ADDENDUM NO.: 3

DATE OF ADDENDUM: October 3, 2012

**Power Plant Boiler Replacement
Connecticut Valley Hospital, Middletown
BI – MH – 974**

ECONOMIZER GAS/OIL VALVE CHANGE OVER LADDER DIAGRAM
SCALE: N.T.S.

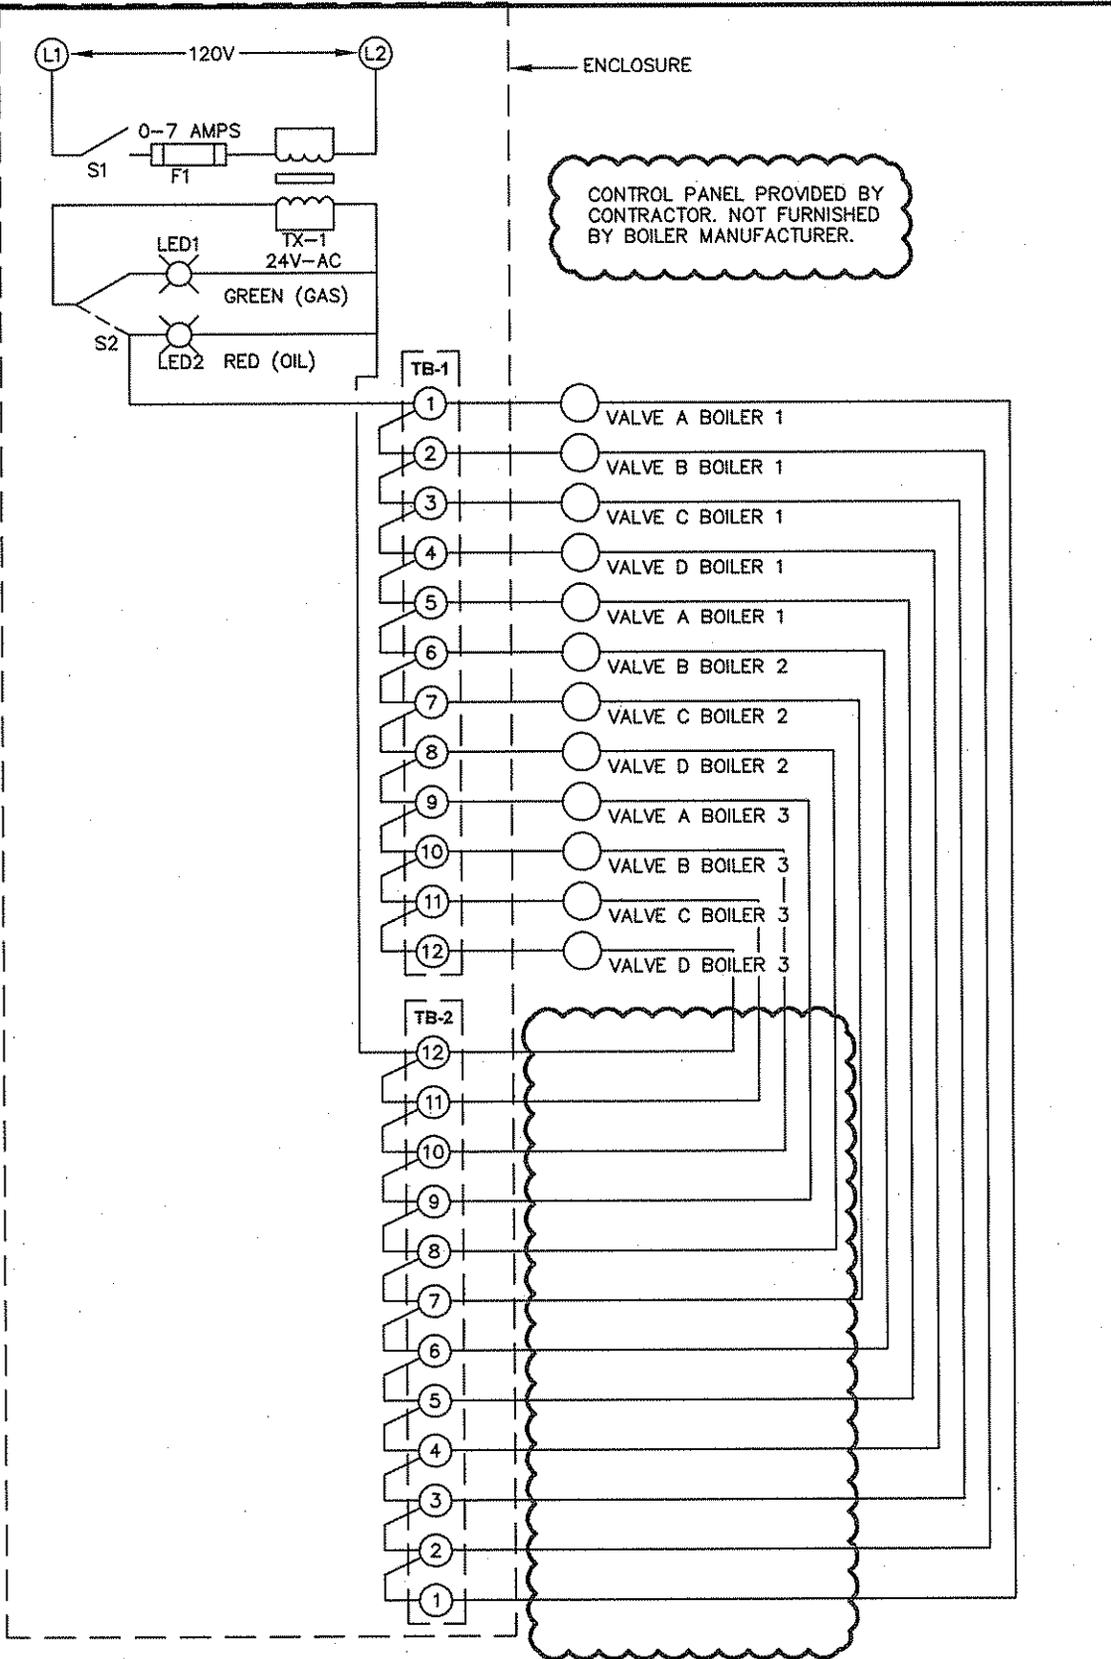
- Question:**
1. Is the Stack Economizer Valve Switching Panel shown on drawing H-3.0 custom built or is it being supplied by an equipment supplier? Also, please check and clarify the ladder diagram wiring, it does not appear to be drawn correctly.
 2. Are the Economizer valves powered open/spring closed?

1. Revised - ECONOMIZER GAS/OIL VALVE CHANGE OVER LADDDED DIAGRAM. See sketch SKH-1.

- 1 See Ladder Diagram Sketch –SKH-001. (attached)
2. The valves are spring return. The normal position of the valves is indicated on the drawing H-3.0.

CONTROL PANEL PROVIDED BY CONTRACTOR. NOT FURNISHED BY BOILER MANUFACTURER.
